RE: Work Plan for Improvements to Wetland Treatment System/
Conveyance System
Former Sinclair Refinery Site: Operable Unit 2
Wellsville, New York
USEPA ID NYD9807773170 / NY Site 902003

**IMPROVEMENTS TO WETLAND
TREATMENT SYSTEM /
CONVEYANCE SYSTEM**

**FORMER SINCLAIR REFINERY
WELLSVILLE, NEW YORK**

Figure 2 - Typical Manhole Installation View

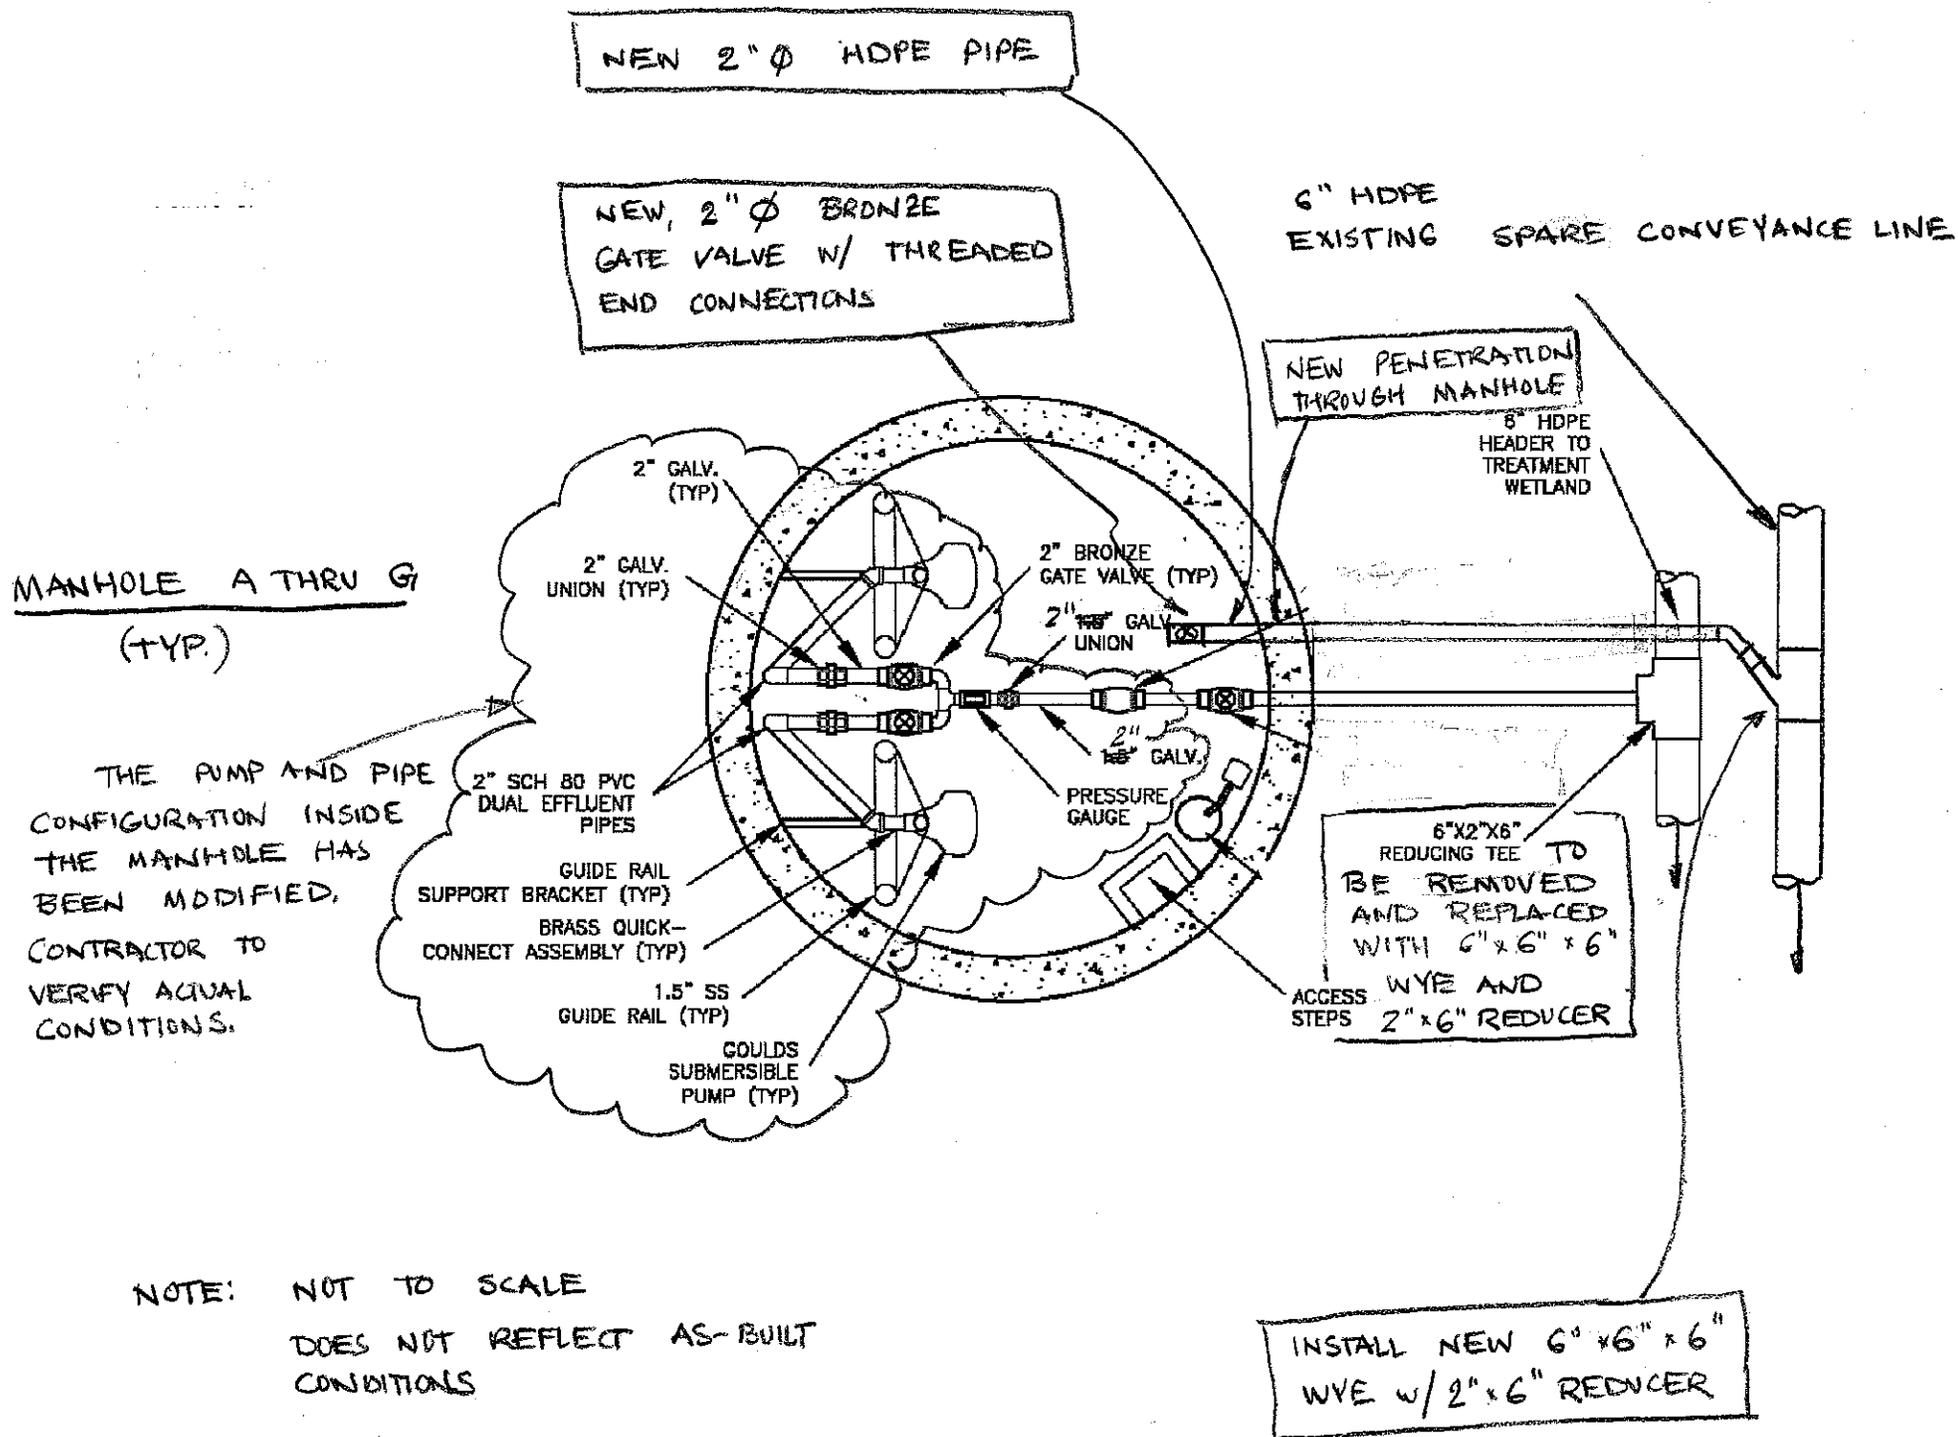
The manhole and pumps currently connect to the 6-inch HDPE conveyance line via 6"x2"x6" tees. The existing tees shall be removed and replaced with a 6"x6"x6" wye fittings with a 2"x6" reducer on the branch. Specification 15060 (Attachment A) provides additional information on the HDPE piping that will be used for these changes. Manholes A, B, C, D, E, and F are currently connected to one line and G and H are connected to a second line. A spare force main line exists but is not in use.

This work shall be done where manholes A through G connect to the conveyance line for a total of seven existing locations (see Figure 2).

Manholes A through F shall be connected to the spare force main in addition to their primary connection (Line A). The existing connections shall remain unchanged. The new connections to the force main shall be a complete and separate connection from the manhole to the spare conveyance line. The attached specification 15060 provides additional information on the HDPE piping that will be used for these additions.

It is assumed that this work will be done in conjunction with the change in line connections outlined under Item 1 above (see Figure 2).

- b. Remove the existing tee connections from the conveyance line. All cuts shall be made neatly and professionally.
- c. Install a 6"x6"x6" wye connection with appropriate reducers on the branch. The wye shall be installed to direct the flow in the same direction as the flow in the conveyance line. The coupling should be connected via permanent fusion type couplings. All work, including pipe preparation, shall be done in accordance with the manufacturer's recommendations.

- d. Cut and remove a section of the existing spare conveyance line as required. All cuts shall be in a neat and professional manner.
- e. Install a 6"x6"x6" inch wye connection with appropriate reducers on the branch. The coupling should be connected via permanent fusion type couplings. All work, including pipe preparation, shall be done in accordance with the manufacturer's recommendations.

- f. Install a 2-inch diameter pipe from the wye at the spare conveyance line, over the existing conveyance line(s), to the manhole. The pipe shall extend a minimum of 6 inches inside the manhole. All fittings between the conveyance line and the manhole should be 45° elbows if possible to provide a smooth flow transition into the conveyance line.

Figure 3

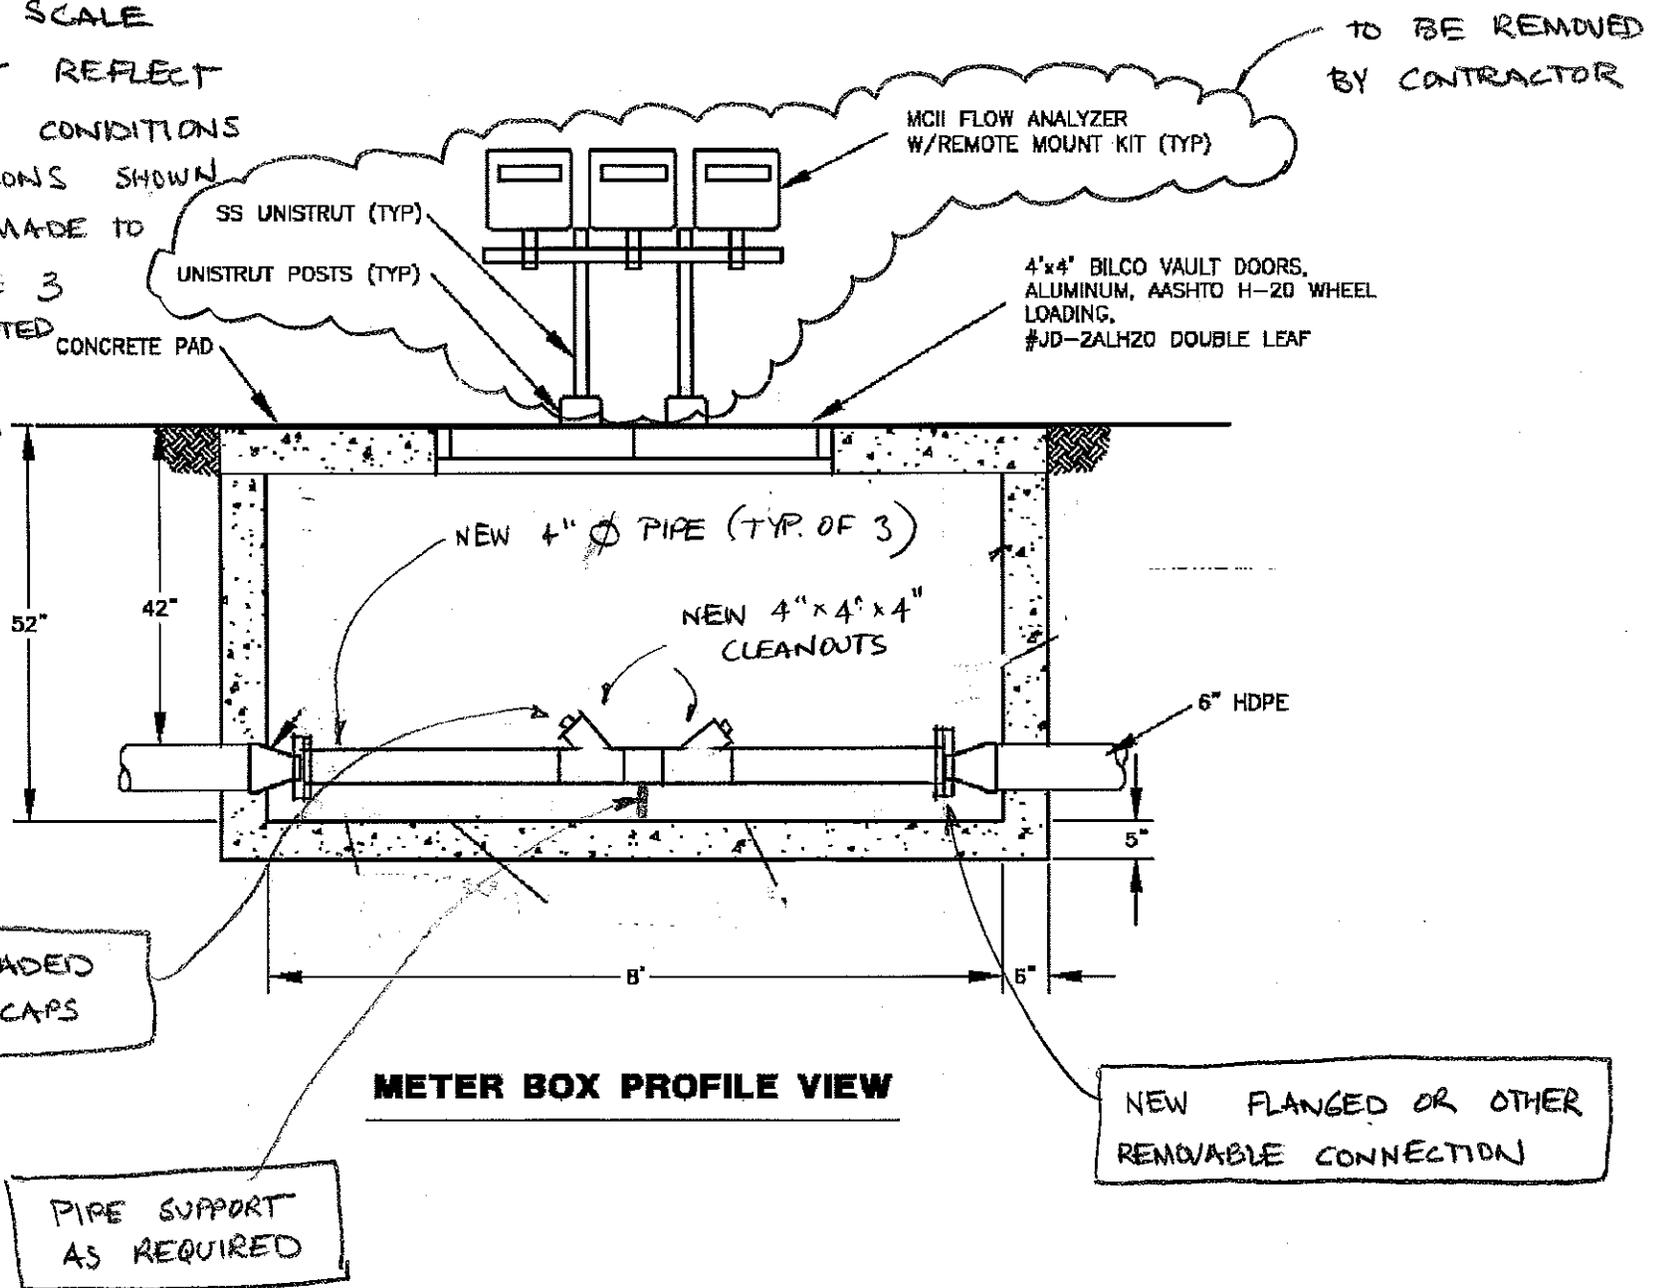
The three meters originally installed in the meter box have been removed and replaced with 2-inch diameter sections of pipe. These 2-inch diameter sections shall be removed and replaced with 4-inch diameter pipe; the pipe shall have cleanout wyes installed in both directions on all three of the lines. The new sections of pipe will be flanged connections to accommodate future removal if required. This work will be conducted on all three of the existing conveyance lines in the meter box (see Figure 3).

- a. Remove all existing 2-inch diameter pipe and other components from the conveyance lines inside the meter pit. All cuts shall be in a neat and professional manner.
- b. All proposed work shall be approved by the Engineer.
- c. Install 4-inch diameter pipe at each of the three conveyance lines. The new 4-inch pipe shall be installed via flanged connections or other connections that are removable. The 4-inch pipe shall not be permanently fused, although the fittings to transition to the flanges (or other couplings) shall be permanently installed.
- d. Each of the three new sections of pipe shall include two 4"x4"x4" wye cleanout fittings. The wye fittings shall be installed in opposite directions to allow for cleaning of the pipe in both directions from the meter pit. The wyes shall be installed with adequate separation between

the fittings and between the fittings and the sidewalls of the meter pit to allow for access to the wye without interference. The wyes shall include threaded end caps on the branch.
